SEWAGE DISPOSAL SYSTEM

MARYLAND STATE DEPARTMENT OF HEALTH*

SUBDIVISION Woodmark ROAD 12139 Mt. Albert Rd LOT 10, Blk D., Sec. 1

RE: Building Permit #67581
Screen Porch
12139 Mt. Albert Road

A REPAIR 36216

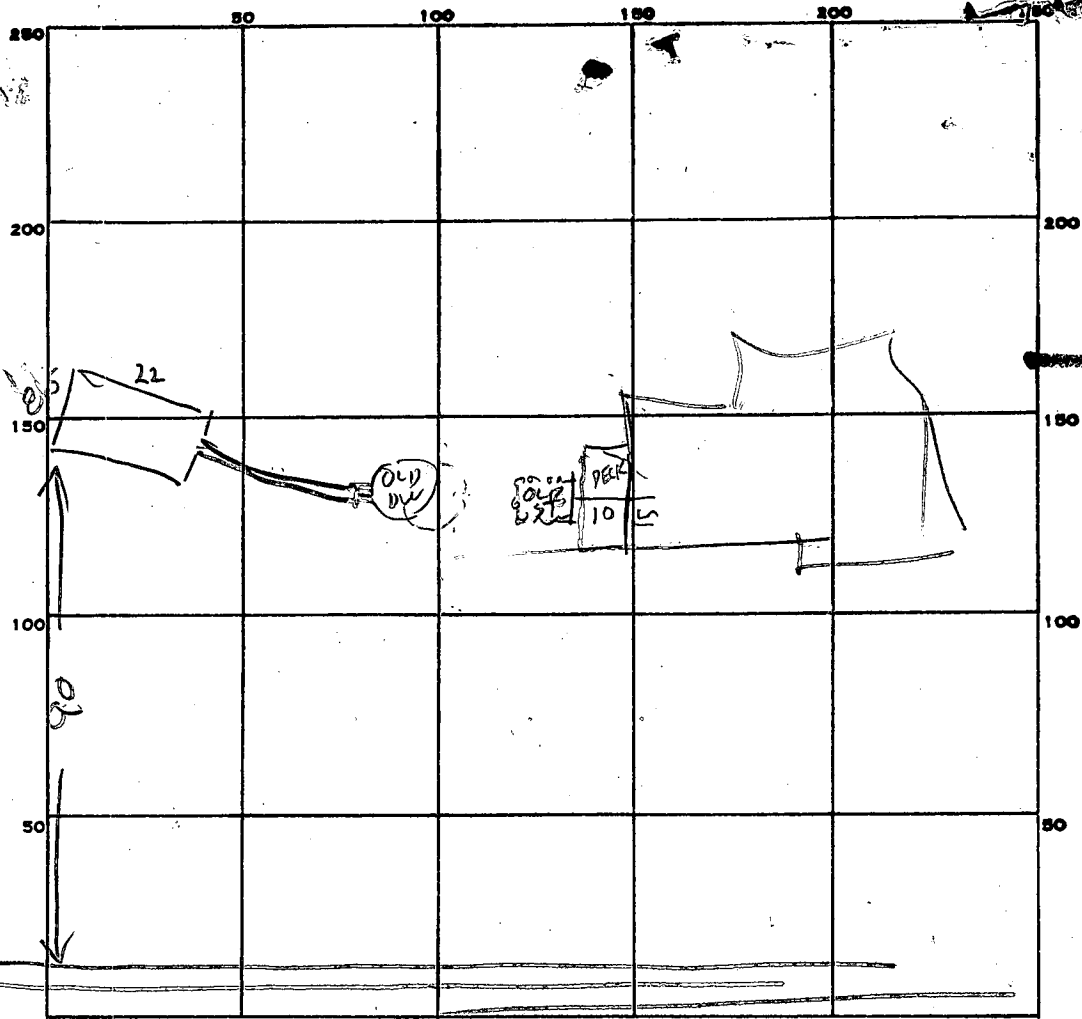
7/13/85 Purpose of Repair is to fix a full
dry well
ROCK DECIDE ON COMBINATION
LEACHING BED & DEEP TRENCH: TOTAL 500
SQFT BOTTOM AREA. RUN DEEP TRENCH OFF DRY
WELL. MAKE DEEP TRENCH 10 FT DEEP 42 FT LONG
2 FT WIDE 7 FT STONE RUN SHALLOW BED OFF DEEP
TRENCH MAKE BED 5 FT DEEP 2 FT WIDE

REMARKS 11/13/85^{AM} - FIRST NARROW 2FT WIDE PART OF TRENCH DUG

IT IS 42 FT LONG 2 FT WIDE 10 FT DEEP & 7 FT STONE RH

11/13/85^{PM} SECOND WIDE BED 8 1/2 FT WIDE X 22 FT LONG 6 FT DEEP

3 FT STONE. TRENCH HAS 284 SQ FT ONE SIDEWALL

AREA. BED HAS 187 SQ FT BOTTOM AREA - TOTAL

471 SQ FT SYSTEM RH

A 12928

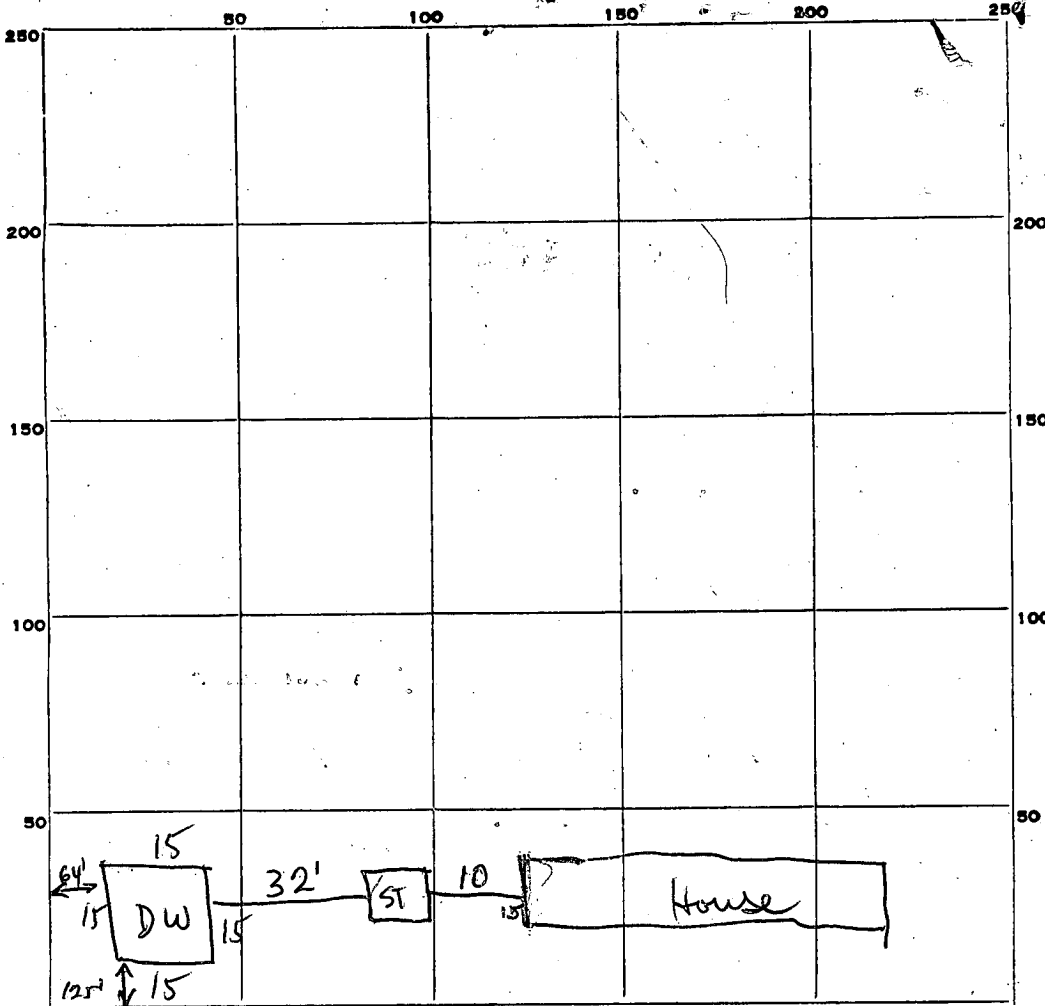
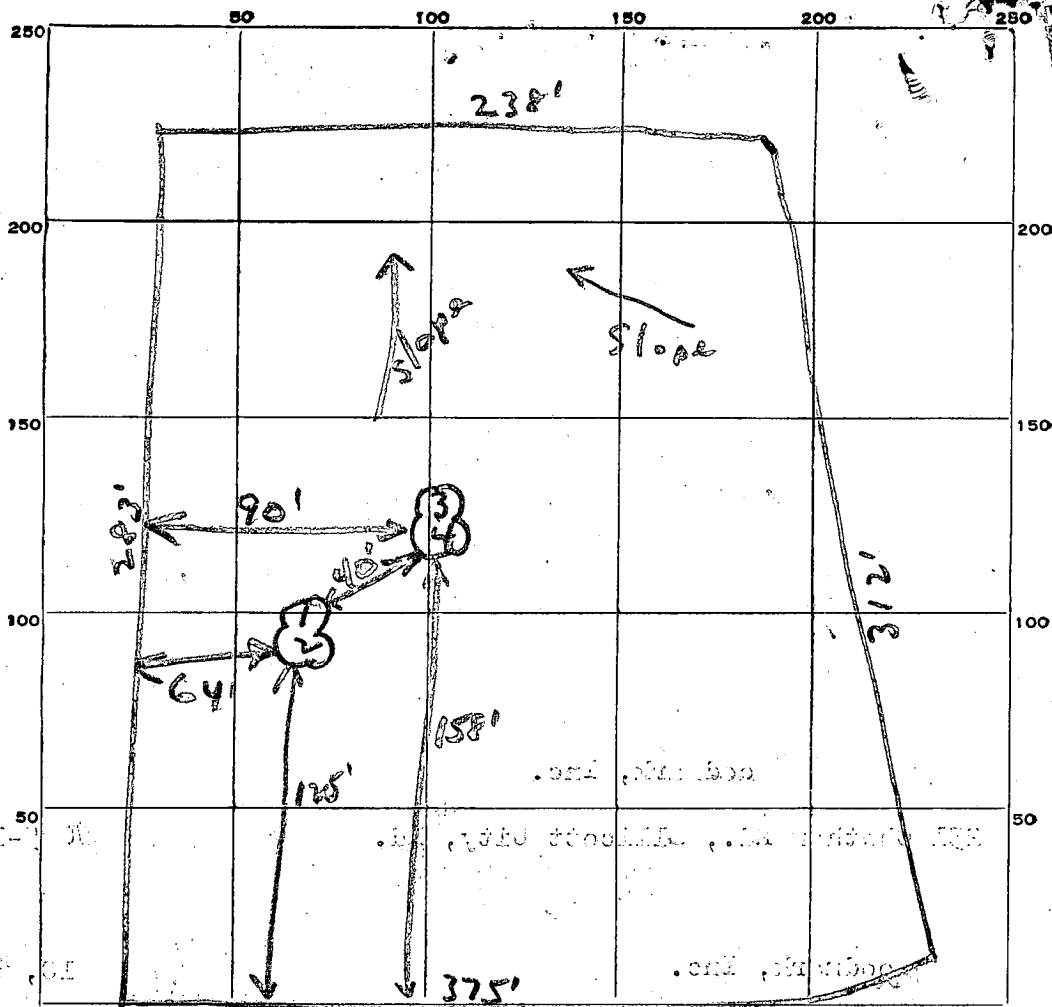
OTHER DRY WELL - 100 sq. ft. absorbent sidewall area below inlet pipe per bedroom. Inlet pipe 4 ft. below original grade. Maximum depth permitted for dry well below original grade is 12 ft. Place dry well 125 ft. from front lot line and 64 ft. from left sideline as seen when facing lot from Mt. Albert Road.

SEEPAGE PITS, INSIDE DIAMETER perimeter 60 FT. DEPTH BELOW INLET 7' FT.

ABSORBENT AREA 420 SQ. FT.

Did NOT SIGN permit card
